REMARKS

Amendments to the Drawings:

Title: REPLACEABLE ROLLER
BOGIE FOR DOCUMENT
FEEDING APPARATUS

Appl. No.: 10/633,126

FIG. 4

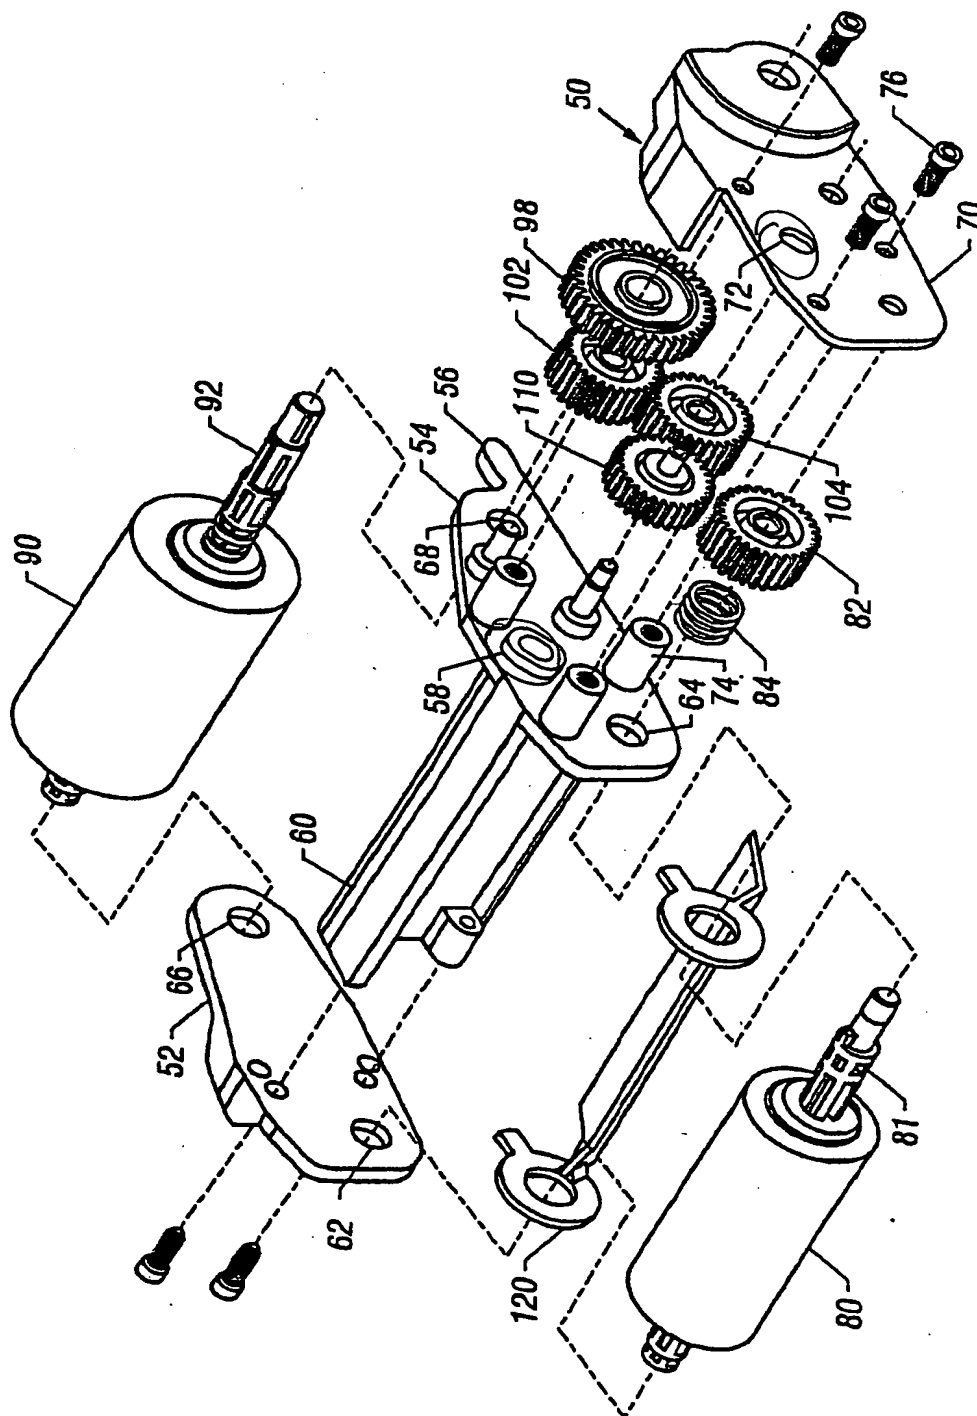
With this Reply, Figure 4 is further amended to correct the angular orientation of slots 58 and 72 as shown in Figure 4 on the attached amended drawing sheet. A replacement sheet including the amended Figure 4 also filed herewith. Support for this amendment is found in Figures 7, 14 and 16A-I through 16-E-3. Thus, no new matter is believed to have been added. In addition, a letter to the official draftsman with annotated drawing sheets of Figures 4 and 10 and replacement sheets of Figures 4 and 10 are also being filed herewith.

Please amend Figures 4 and 10 as indicated in red and circled on the attached annotated drawing sheet. Replacement drawing sheets including Figures 4 and 10 are also being filed herewith.

FIG. 10

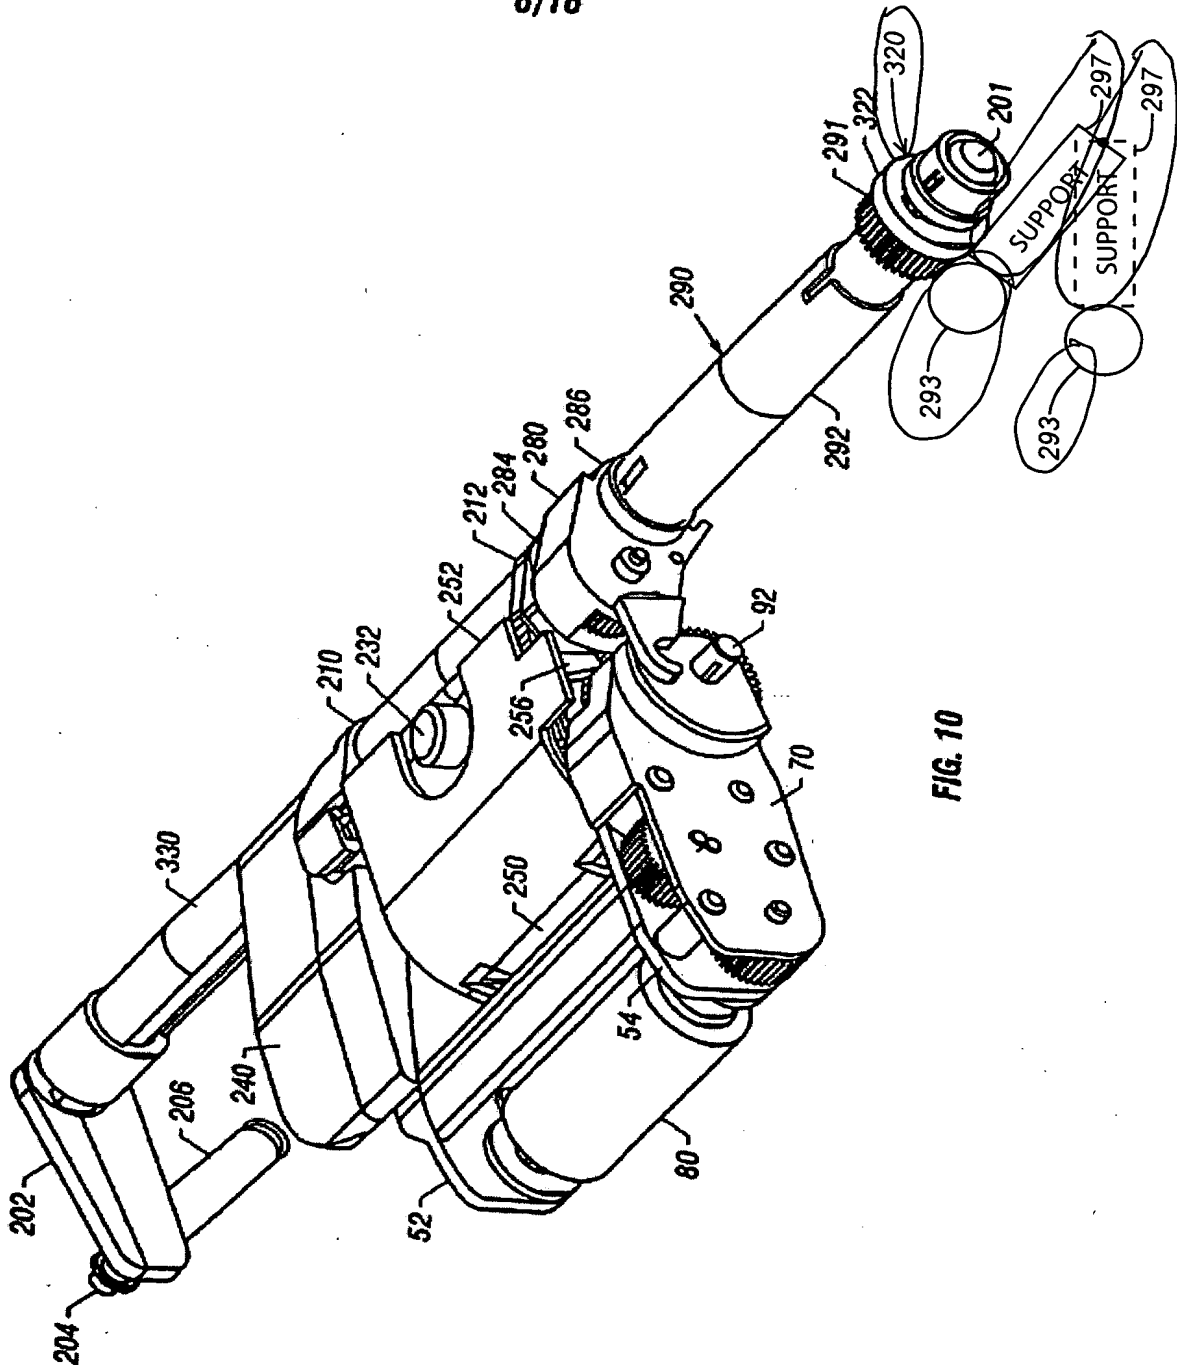
Page 2 of the Office Action objected to the drawings under 37 CFR § 1.83(a). In particular, page 2 of the Office Action requested that the motor-driven output gear and the pivotal motor output gear support be shown or cancelled from the claims. In response, Figure 10 of the drawings is amended to schematically illustrate a motor-driven output gear 293 and the pivotal motor output gear support 297. Figure 10 specifically illustrates pivoting of the support 297 into and out of engagement with surface 322 of retainer 320 such that motor output gear 293 moves into and out of engagement with input gear 291. Applicants respectfully note that one of ordinary skill in the art would understand what a “gear” is. Applicants respectfully note that one of ordinary skill in the art would understand what a “support” for a gear is. In particular, a support for a gear is a member which supports the gear. The claims do not require any specific structure for the support. Rather, the claims merely state that the support engages the cylindrical surface 322 when gear 293 is engaged to gear 291. Figure 10, as amended, illustrates what is described and supported in originally filed paragraph [0033] of the Specification. Accordingly, no new matter is believed to have been added.

Applicants respectfully note that the claimed motion limiter refers to the surface 322 of retainer 320 shown in Figure 10 and described in originally filed paragraph [0033]. Paragraph [0033], as originally filed, recited that:

To further clarify where support may be found for the recited “motion limiter” in Claims 22-24, paragraph [0033] of the Specification is amended to recite that the cylindrical surface 322 “acts as a motion limiter by engaging motor output gear support.” Accordingly, Applicants respectfully request that the objection to the specification as failing to provide proper antecedent basis for the subject matter of Claims 22-24 be withdrawn.
